Montana Department of
ENVIRONMENTAL QUALITY

In the Matter of Determination of Substantive
Compliance with the Montana Major
Facility Siting Act for Western Area Power
Administration's Proposed Rebuild of the
Havre to Rainbow 161-kV
Transmission Line

DRAFT CONCLUSIONS AND
DETERMINATION

Attachment 2: Great Falls Switchyard Area

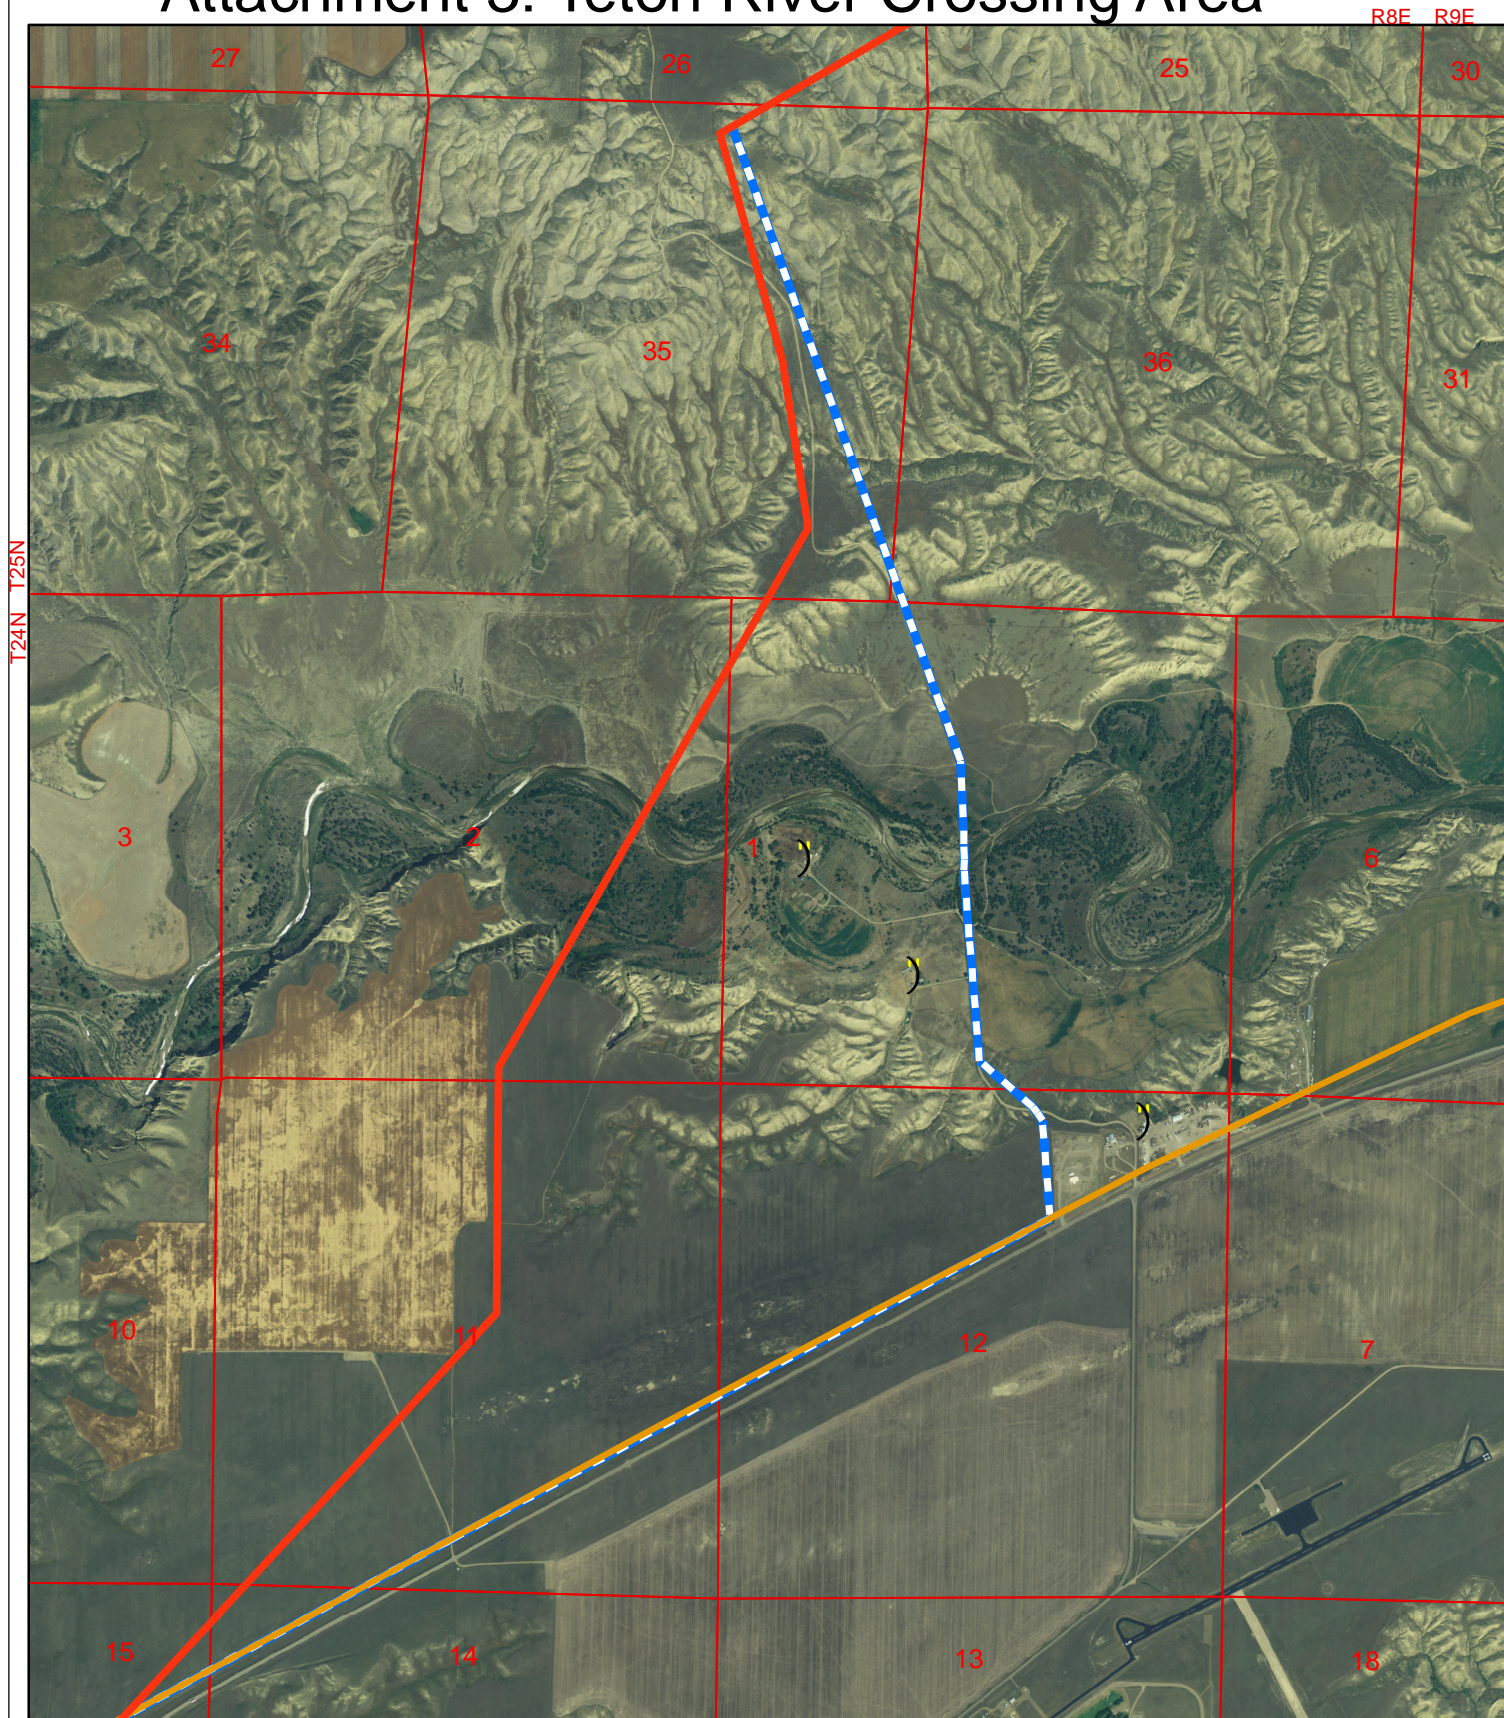
Near Great Falls, the current transmission line connects to the Rainbow Substation. Western is seeking approval of an option to reroute the transmission line so that it connects to the Great Falls 230-kV Switchyard which is located northwest of the Rainbow Substation. If Western were to relocate the transmission line under this option, 230-kV transformers would have to be installed at the Great Falls 230-kV Switchyard.

The current transmission line and the optional relocation of the transmission line to the Great Falls 230-kV Switchyard crosses a tract of land that is subject to a conservation easement granted to the Conservation Fund by the Montana Power Company in 1999. The easement was subsequently assigned to Montana Fish, Wildlife and Parks. Language in the conservation easement indicates that the grantor, Montana Power Company, “wishes to protect and conserve the Land so as to protect and enhance the open space resources where consistent with its hydropower production and power transmission activities,” and the “Grantor’s wish to implement a policy to consolidate power lines and substations in certain areas to the extent practicable to reduce visual impacts when siting, constructing, replacing, and upgrading facilities” *Lewis and Clark Heritage Greenway Deed of Conservation Easement July 22, 1999*

As indicated in the EA, a significant impact could occur if the project resulted in the development of the conservation easement land that conflicted with easement stipulations. The option sought by Western would relocate the transmission line along the northern boundary of the tract subject to the easement. Attachment 2 shows the location of the optional relocation of the transmission line to connect to the Great Falls 230-kV Switchyard. Land use in the area is a mix of range, pasture, and non-irrigated cropland. No residences are present. Another transmission line connecting to the switchyard to be built by MATL is proposed to be located along a portion of the northern boundary. Transmission lines owned by PPL may also be consolidated in this location as well. The Montana Fish, Wildlife and Parks concurs with relocating the transmission line along the northern easement boundary.

- D. North of the Rainbow Substation, Western is considering relocating the line to connect to NorthWestern Energy's Great Falls 230-kV Switchyard. If terms of the conservation easement contain no restrictions on line location, the Department would allow the proposed line to be located along field boundaries in an area depicted on Attachment 2 after a Class III cultural resources survey is conducted. If significant cultural resources are discovered, mitigating measures such as adjustment of the centerline and pole locations shall be made to avoid the impact. If cultural impacts are unavoidable, Western shall follow the direction of the State Historic Preservation Officer.

Attachment 3: Teton River Crossing Area

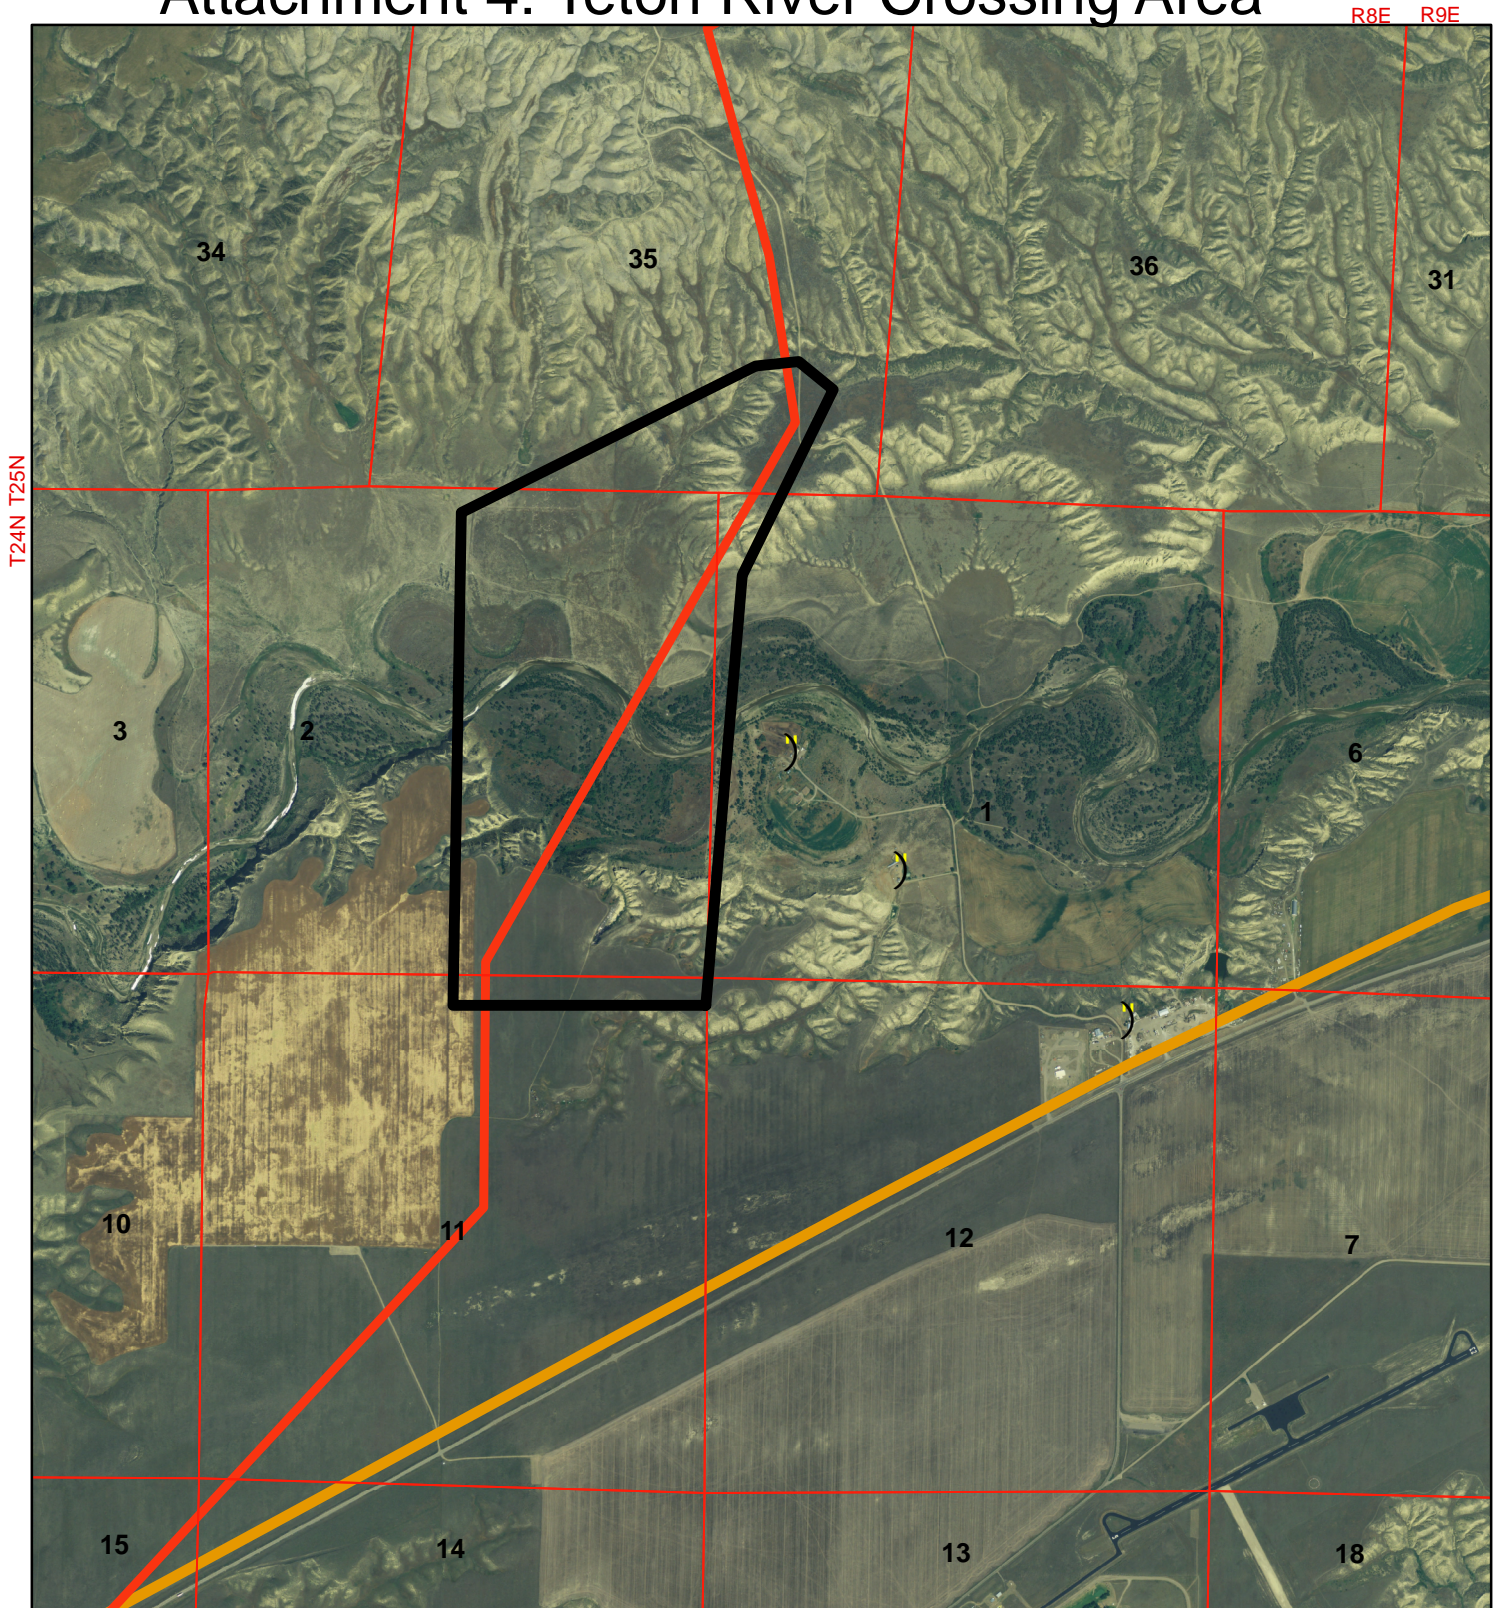
Since publication of the EA, Western has indicated that a possible line adjustment was considered at the Teton River crossing (Attachment 3). A new location east of the proposed line location was studied in an attempt to address landowner concerns related to potential property development for recreational residences. Compared to Western's proposed location, the new location would cross an additional 2.56 miles of farmland (now enrolled in the CRP program), increasing potential impacts from having to farm around structures if CRP land is converted to farmland. The new location would also be located within 1/4 mile of two residences, increasing visual impact to those residences. Finally, the new location would be approximately 0.7 mile longer than the proposed location, increasing the line's construction cost. As such, the new

location fails to reduce impacts to the extent achieved by Western's initial proposal. Following a cultural resources survey, the Department would allow the proposed line to be located within an area at the Teton River crossing depicted on Attachment 3 to reduce impacts to potential recreational development. If significant cultural resources are discovered, mitigating measures such as adjustment of the centerline and pole locations shall be made to avoid the impact. If cultural resource impacts are unavoidable, Western shall follow the direction of the State Historic Preservation Officer.
